DART SERVICE INSTRUCTION

TO AMEND INSTALLATION INSTRUCTIONS II145-6 Rev. A,
REF. TCCA STC: SH21-24
REF. EASA STC: 10077436
REF. FAA STC: SR04694NY

The purpose of this DART Service Instruction is to provide the installer with instructions for correcting these deficiencies.

FIGURE 1: RIVET REPLACEMENT LOCATION

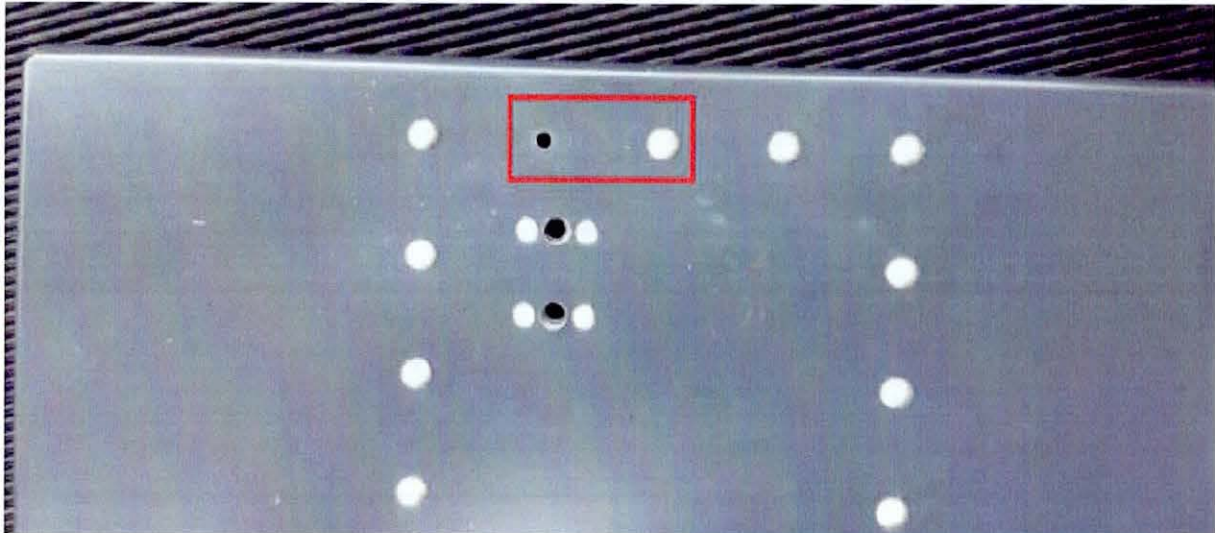
1. Dimple the aluminum panel in the required rivet locations as shown in Figure 1 of this DSI in accordance with the Aircraft Maintenance Manual.
2. Replace rivet F/N 89, MS20470AD3-3, with countersunk rivet, DIN65399-3205BF.

FIGURE 2: OEM LOWER BRACKET PIN

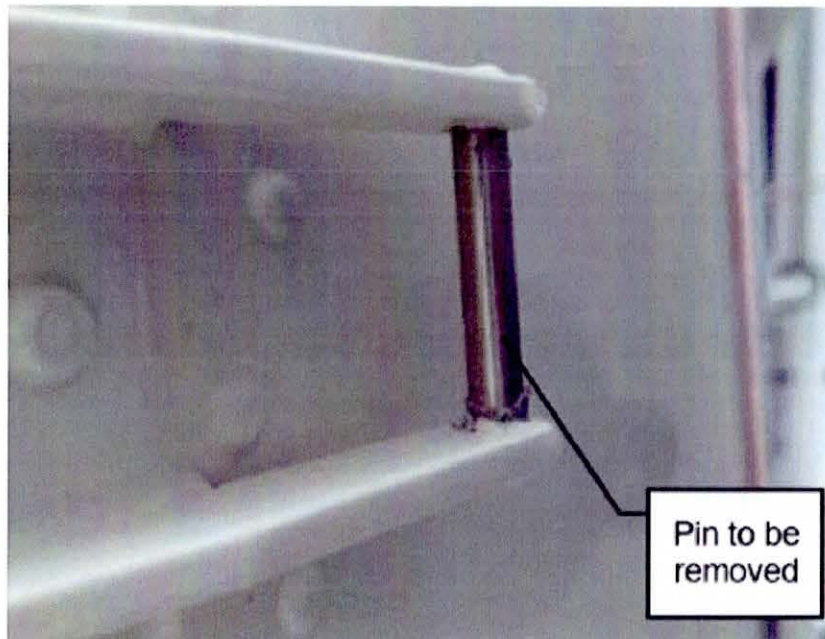
1. Remove the pressed pin, located on the OEM lower bracket, shown in Figure 2 of this DSI.
2. When installing the DART reservoir bracket, P/N 651.4010, on the OEM fixed provisions, use the alternate hardware listed in Table 4 on page 14 of II145-6 Rev. A.
3. The bushings (P/N 654.9810) internal diameter can be increased by up to 0.03" (.75 mm) to allow for proper fitment of the DART removable hardware onto the OEM fixed provisions.
4. Complete the installation of the DART brackets and reservoir per Section 2.3 of II145-6 Rev. A.

Pin to be removed

FIGURE 3: FLOAT RESERVOIR ALIGNMENT (APPROX. DIM.), RH HC VIEW

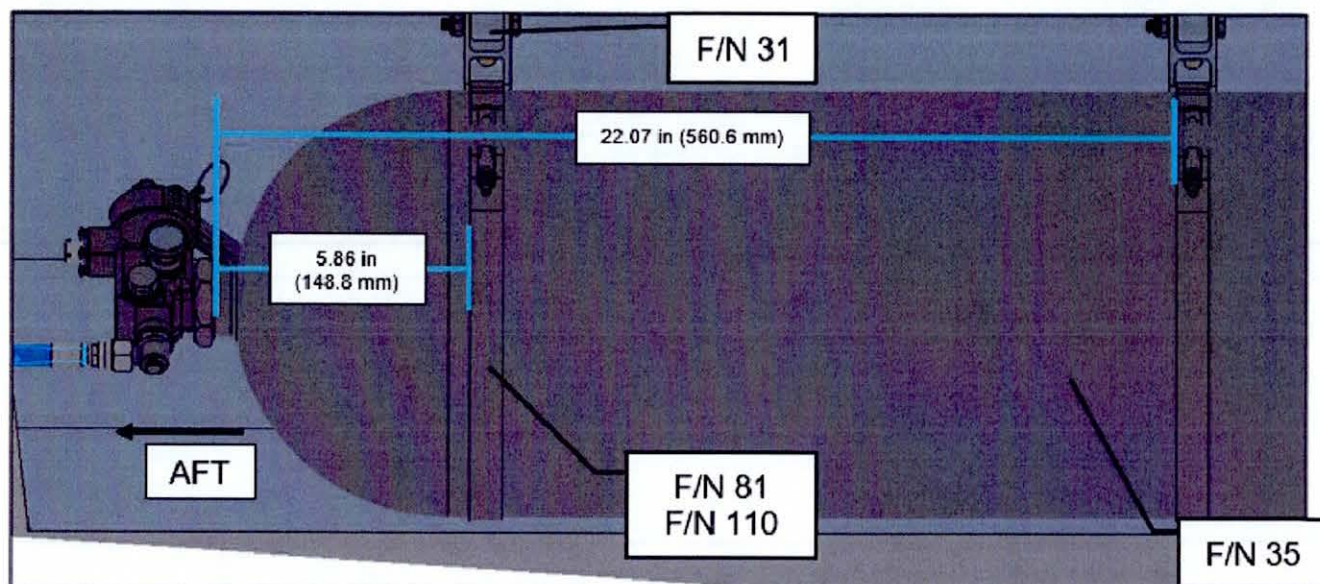
1. Reference Figure 3 of this DSI for the correct alignment of the Float Reservoir.
2. It is acceptable to shift the Float Reservoir aft by up to 2.90" (73.7 mm) to avoid interference with the DME antenna. If the bottle is shifted, the installer must confirm that the cable installation conforms to the NOTE on the bottom of page 50 of II145-6 Rev. A as well as the pull force requirements per Section 8.0 of II145-6 Rev. A.

NOTE: The float reservoir may be shifted by up to 2.90" (73.7 mm) aft of the dimensions shown in this figure to avoid interference with the DME antenna

FIGURE 4: LIFERAFT RESERVOIR CLAMP ALIGNMENT

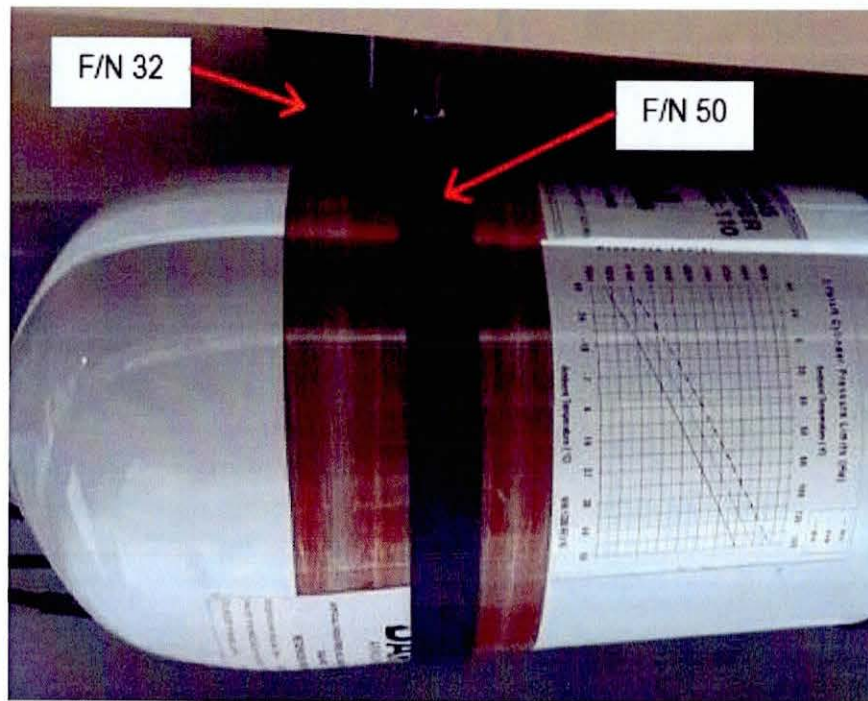
1. It is acceptable to install the clamp assemblies (F/N 50) such that the bolts are internal to the bracket assemblies (F/N 32) to prevent interference with passenger entry. Reference Figure 4 of this DSI for optional clamp orientation.
2. Reference Figure 5 for correct alignment of the Liferaft Reservoir. It is acceptable to shift the bottle aft by 1.0" (25.4 mm) while ensuring that the valve assembly clears the existing drain. If the bottle is shifted, the installer must confirm that the cable installation conforms to the NOTE on the bottom of page 57 of II145-6 Rev. A as well as the pull force requirements per Section 10.2 of II145-6 Rev. A.
3. It is acceptable to use either two washers or one washer (F/N 54) per bolt (F/N 56) to install the multi-cable box (F/N 60) to the cable box mount assembly (F/N 33) per Figure 15 of II145-6 Rev. A.

FIGURE 6: CLICK BOND LOCATION (APPROX. DIM.)

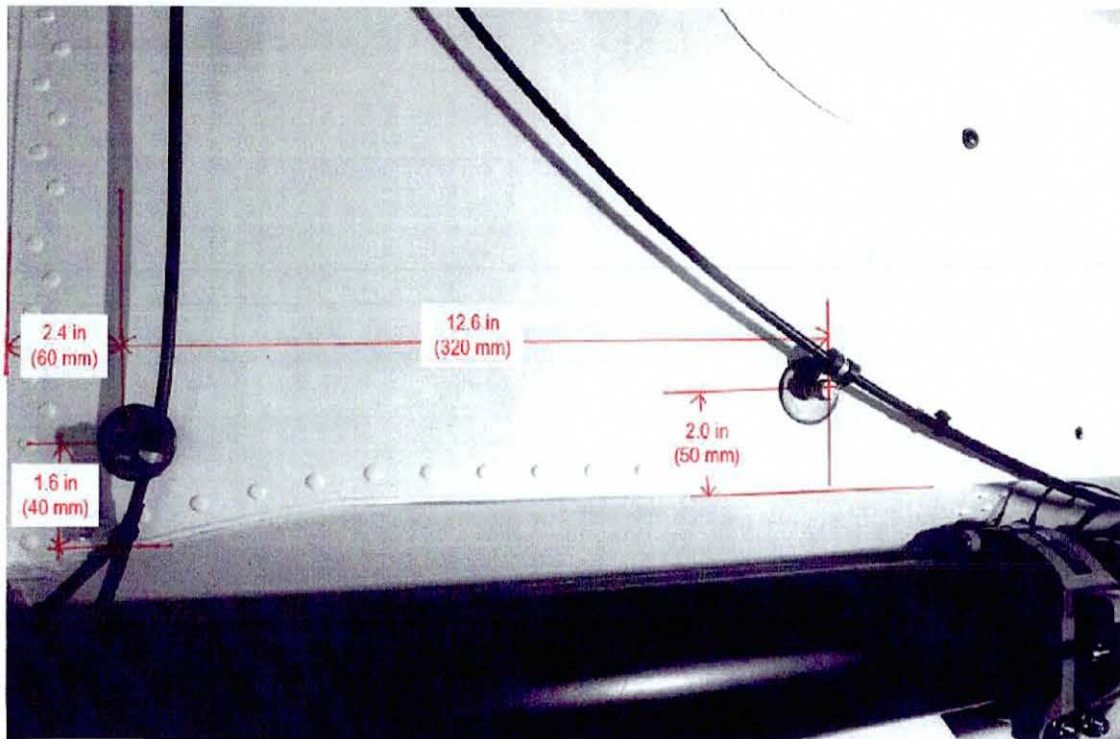
1. Rubber material may be used between the pull cables and Tywraps to allow for minimal cable movement and reduce chafing on the pull cables.
2. Reference Figure 6 - Figure 11 of this DSI for acceptable Click Bond (F/N 37) locations. A tolerance of 2.0" (50 mm) is acceptable on all dimensions. Additional Click Bonds may be required to remove any slack that may cause contact with the aircraft or other surrounding features.
3. The installer must confirm that the cable installation conforms to the NOTE on the bottom of page 50/57 of II145-6 Rev. A as well as the pull force requirements per Section 8.0 and Section 10.2 of II145-6 Rev. A.
